Determination 2013/042

Regarding compliance with the Building Code and with the building consent of roof structure components installed in a house at 16 Highland Drive, Richmond

Figure 1: The valley gutters as built

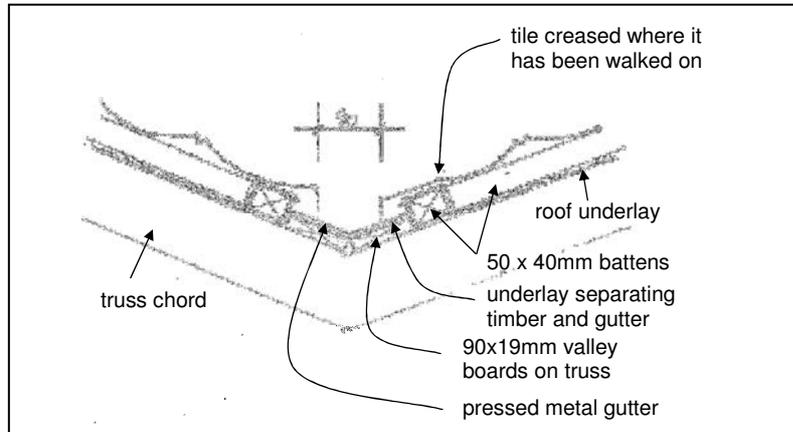
5.4.6 The expert provided an as built valley gutter detail (refer Figure 1) and noted the differences between the as built, E2/AS1 and the metal roof tile manufacturer's specifications (refer Appendix A) as follows:

- truss layout plan 'called up' the valley boards (the truss layout plan states 'Also supply... 92m 200x25 H4 valley boards')
- the valley boards are not located as per E2/AS1 or the tile manufacturer's specifications; both the manufacturer's manual and the Acceptable Solution show valley boards to be cut between, not located on top of, the trusses

- the valley is not wide enough to walk in.
- 5.4.7 The expert noted that the valley boards on top of the truss effectively reduce the amount of upstand that can be formed on the valley gutter. The manufacturer's manual and the Acceptable Solution show the upstand at 35mm and 20mm respectively. The tile batten is 40mm thick and the valley board is 19mm thick, which establishes the effective valley gutter upstand height as 21mm.

- 5.4.8 The expert noted that there was no return on the top edge of the valley gutter upstand and a continuous batten has been fixed each side of the gutter. Damage was apparent to the tiles where the batten adjacent to the gutter has been walked on.

- 5.4.9 The expert observed no evidence of moisture ingress, and considered that the reduced size of the valley board would not compromise the function of the board. The expert noted that the valley boards are not connected to the continuous batten adjacent to the gutter; the continuous battens span up to 1.8m.

6.3.5 The valley gutters have a reduced cross-sectional area and therefore a lower capacity than that described in E2/AS1. The valley gutters collect water from relatively small areas of roof; the expert observed no water ingress adjacent the gutters and the gutters have been subject to several severe rainfall events since their completion. I consider the valley gutters are adequate in terms of the collection of water from the roof.

6.3.8 While the valley boards are not wide enough to walk on, the 50x40mm continuous batten adjacent the boards will be walked on: the continuous batten spans up to 1.8m. An internal review by the Ministry has found that the continuous batten will resist wind uplift, but it is not adequate in terms of the live load from a person on the roof. The framing immediately adjacent the gutter does not comply with Clause B1 and additional support under the continuous batten is required.
